## Technical Opinion

**RE:** Technical Opinion, Pointe Estates Development

*Technical Opinion*  
*Evaluation Of The Proposed Pointe Estates Development,*  
*Sault Ste. Marie, Ontario Canada*

MOE Well Location Error

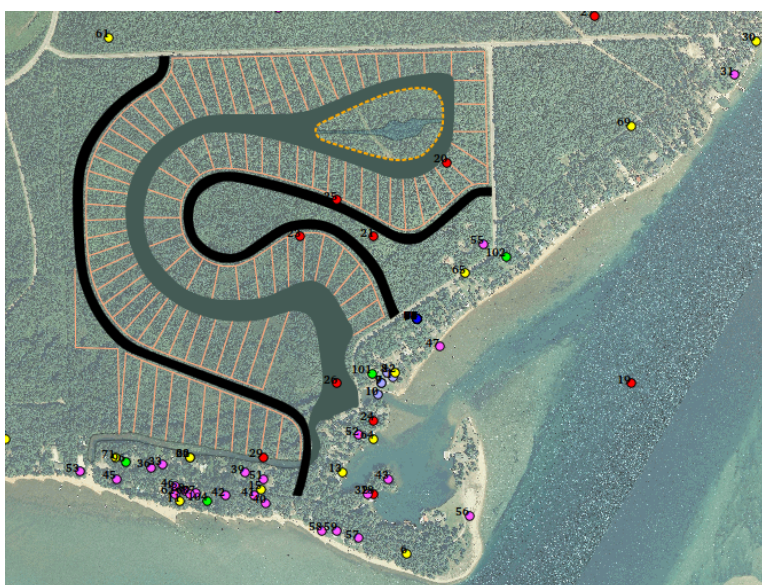
Characterization of the geology and hydrogeology in the area of the Pointe Estates Development was interpreted based on geologic information in the Ontario Ministry of Environment (MOE) on-line database provided in Appendix B<sup>4</sup>. The MOE database contains geologic, hydrogeologic, well construction, and location information for groundwater wells in Ontario. Information provided in the database was obtained primarily from well drillers dating back numerous decades, and, therefore, some errors as to the location of wells is present. Well location data presented in the database does provide information regarding the error associated with the spatial location of the wells (Figure 3). A number of the wells located within the proposed development, including wells 20, 21, 23, 25, 26, and 29, have location errors in the range of 300 meters to 1 kilometer. Inspection of the aerial photograph does not indicate the presence of residences in the area of these wells, and, therefore, a low degree of confidence in the location of these wells needs to be assumed. Well 19, plotted in the St. Marys River, is obviously incorrectly located in the database.

In addition to the error identified in the MOE database, comparison of the ground elevations at each location with the elevation presented in the MOE database (Figure 4) was conducted to identify

any errors associated with calculating the depths of each geologic unit. Ground elevations were obtained for each location using the electronic digital elevation map file<sup>5</sup> and compared with the location information presented in the MOE data. The results of this analysis is presented in Figure 4 and indicates that with the exception of wells 6, 57, 58, and 59, located along the shoreline, vertical errors were less than 1 meter.

In conducting the geologic characterization in this effort, as well as in the previous preliminary hydrogeologic report [10], it is assumed that the well locations are reasonable. The only exception is that well 19 was removed from consideration in this analysis due to it's obvious error. It is strongly recommended that the well locations be accurately identified and the geologic information re-evaluated before this information is used in any additional hydrogeologic studies in order to best characterize where additional borings are needed.

Three Dimensional Geologic Model

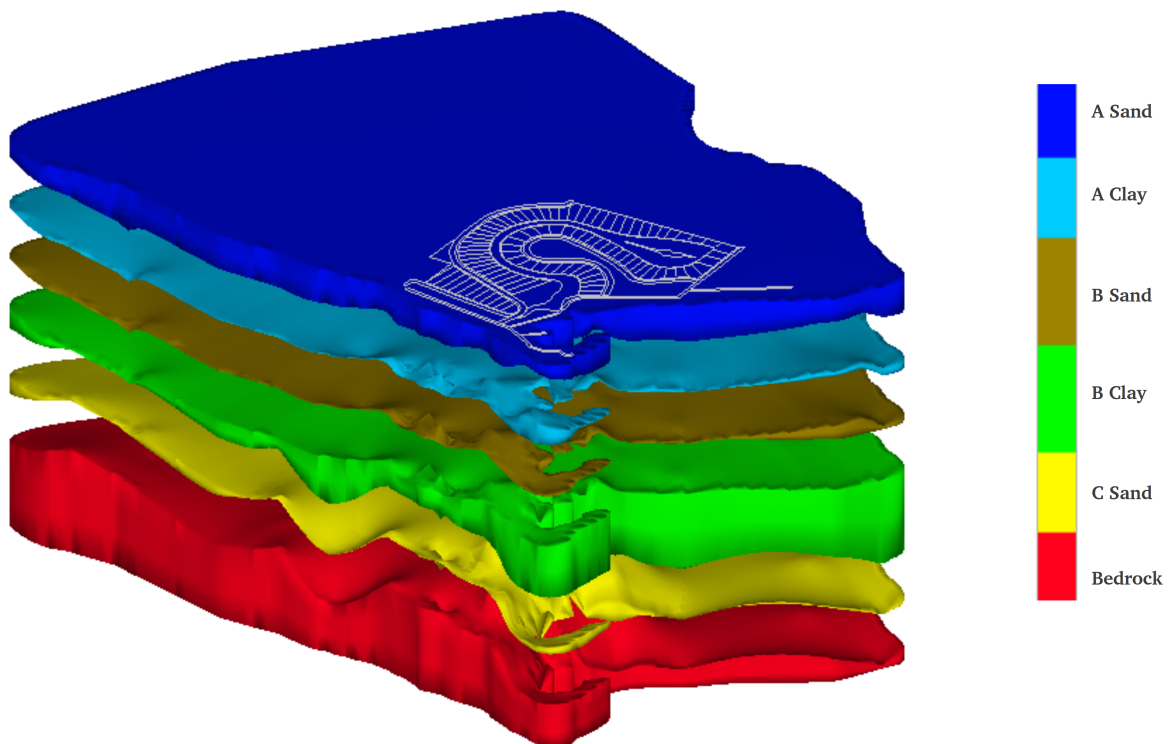
The geology around the proposed Pointe Estates Development was evaluated by developing a three dimensional geologic model based on the information presented in the MOE database<sup>7</sup> (Table 1). The geology of the Pointe Estates area consists of a sequence of sands, gravels, and clays comprising the glaciolacustrine and lacustrine shallow water deposits[1]<sup>8</sup> overlying a sandstone bedrock aquifer which is used as a sole source aquifer for domestic water wells. As previously discussed, the site is located on the western extent of the West Basin where a significant rise in the elevation of the bedrock surface occurs changing from 60 meters msl within the central portion of the West Basin to 140 meters msl in the area of the proposed development. This represents a rise of ~80 meters over a distance of ~5 kilometers. A closer evaluation of the thickness of overburden based on the MOE dataset indicates six geologic units in the Pointe Estates area identified as follows: A Sand, A Clay, B Sand, B Clay, C Sand, and Bedrock. The A Clay, B Sand, and C Sand units are intermittent across the study area and are considered inconsequential. A description of each of these units is presented.

The A Sand unit is the dominant sand unit underlying the proposed development. This is the unit where the septic systems will be installed. The sand unit thickness is approximately 35 to 40 feet thick in a north south direction through the proposed development, thickening in an easterly and westerly direction. The thinnest portion of the A Sand is in the southern portion of the development in the vicinity of the Alagash with a thickness of approximately 25 feet (Figure 5).

The B Clay unit is a confining unit which separates the upper sand units from the bedrock aquifer. This clay unit is thickest in the northern portion of the proposed development, thinning in a south-westerly direction. The B Clay is an important geologic unit since its presence will prevent the vertical migration of septic tank effluent from the upper A Sand downward to the bedrock aquifer. Of particular concern is Boring 29 (MOE Well ID 11-01297) which indicates a clay thickness of 3 feet or less than 1 meter (Figure 6). The location error of this boring, however, is high, between 300 meters to 1 kilometer. The kriging analysis indicates that the clay thickness in the southern portion of the development is thin to non-existent. As will be discussed, this is a result of the clay thickness in Boring 29 as well as the rising bedrock surface beneath the clay. The model analysis of the B Clay in the southern portion of the development should therefore be interpreted as possible clay thickness, but, also, clearly indicates a significant datagap that must be addressed in the hydrogeologic study.

Conceptual Diagram of Lot Sizes Related to Plume Concentration

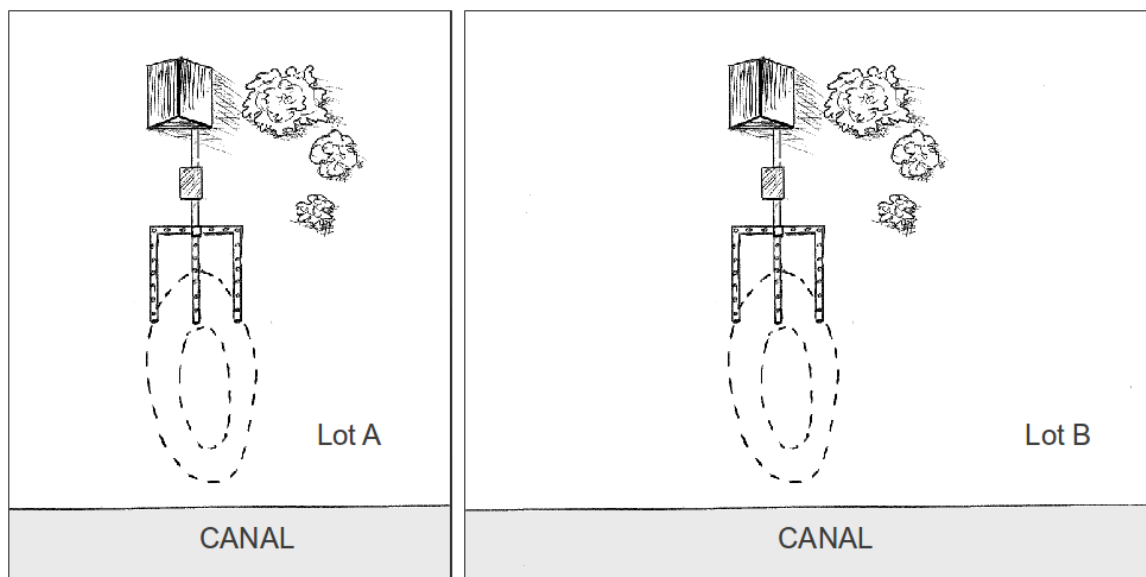
One conclusion of particular concern was made regarding the impact of lot sizes[10] as taken from provincial guidance<sup>15</sup>[8]. Excerpts regarding this analysis include:<sup>16</sup>

- *“The assessment considers the nitrogen loading from a single on-site sewage system to the water table aquifer beneath each property, based on a simple-dilution mixing model. The source concentration of nitrate-nitrogen is set at 40 mg/L (as N), and the daily discharge volume for a single family residential unit is set at 1000 L/day/lot (Procedure D-5-4).”*
- *“The effluent from the on-site system, once entering into the subsurface, is then considered to mix with fresh rainwater infiltration over the entire property area, thereby achieving a dilution of the concentration of nitrate-nitrogen prior to any off-site discharges from the lot.”*

These statements and the resulting calculation regarding lot sizes are completely erroneous, technically incorrect, and misleading. The simple idea that an arbitrary factor such as lot size will dilute the concentration of nitrate-nitrogen from the septic system is simply wrong.

Consider the following conceptual illustration depicting two lots, Lot A and Lot B.

Both lots are adjacent to the proposed canal and both are identical, except for the lot sizes. Lot A has a lot size approximately half the size of Lot B. In both these cases, the distance from the septic tank tile field to the canal is the same and the chemical plumes from both septic systems are also equal. Since both plumes are migrating towards the canal, the discharge concentrations from each system is the same, regardless of the lot size. Infiltrating water onto the lots will not mix more with the plume on Lot B than on Lot A since lot size is arbitrary and has nothing to do with the hydrologic processes of mixing of infiltrating rainwater with each plume.

Summary of Ship Passages According to Vessel Length

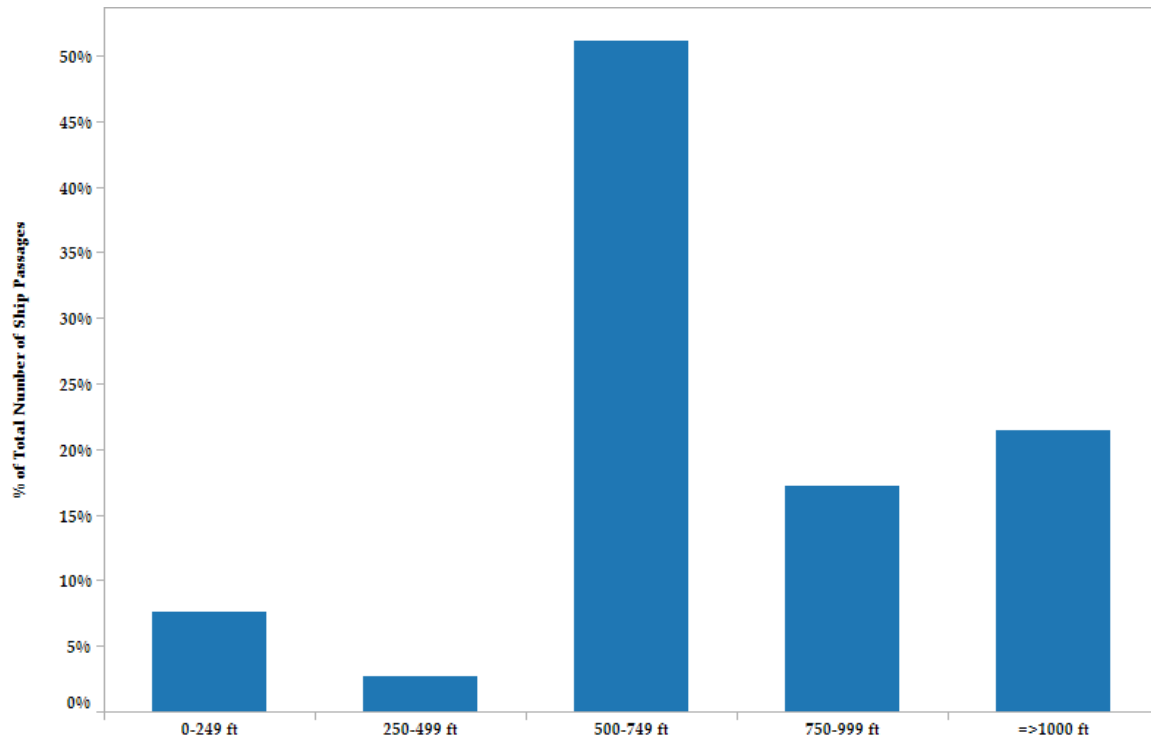
As discussed in the hydraulic report, critical to the hydrologic modeling and canal / river water exchange, is the passage of ships in the St. Marys River. The assumption in the modeling effort was that, on average, 6000 large commercial vessels will pass by Pointe Louise, many of which are 1,000 foot or greater. In order to evaluate this assumption, ship passage records for the Sault Locks were obtained <sup>21</sup> and dimensions and dates of passage for each ship were compiled into a database for the shipping year 2010 (Table 2).

Over the 2010 shipping year, there was a total of 4,216 passages which was less than 75% of the 6000 passages assumed in the hydraulic model. Also, since the Sault Locks are closed during a

portion of the winter months, there were no passages between January, 16 and March 20, 2010. Therefore a continuous exchange of water as a result of ship passage throughout the year cannot be assumed.

Comparison of ship passages with the dimensions of each ship indicates that only approximately 22% of the vessels passing through the Sault Locks were 1000 ft or greater, with the majority (~50%) being between 500-749 feet.

Hydraulic Model Simulation of the Inlet Bay

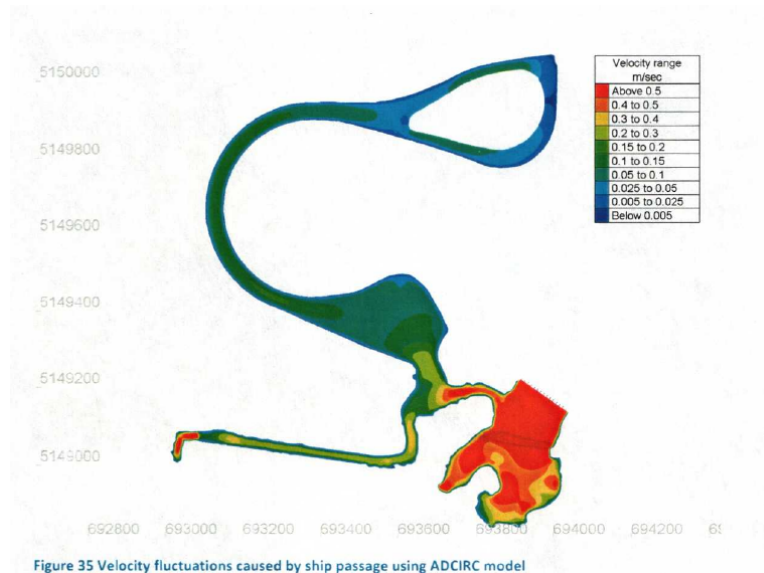
Therefore, based on the available data from 2010, the primary assumptions of the size and frequency of freighter passages is less than the assumptions in the model indicating that the hydraulic model overestimated the influence of shipping on the exchange of water between the proposed canal and the St. Marys River.

The basic idea behind this proposed flushing is that water discharged from the canal will mix and dilute with water in the St. Marys River. However, while mixing of waters in this manner does not occur under normal flow conditions, the additional factor regarding the inlet bay needs to be considered. In the hydraulic modeling[3], it was concluded that wave action will be significant in the inlet bay.

Based on the results of the hydraulic model, water from the St. Marys River will flow into the inlet bay more than in the proposed canal. It is reasonable, therefore, to assume that the water from the
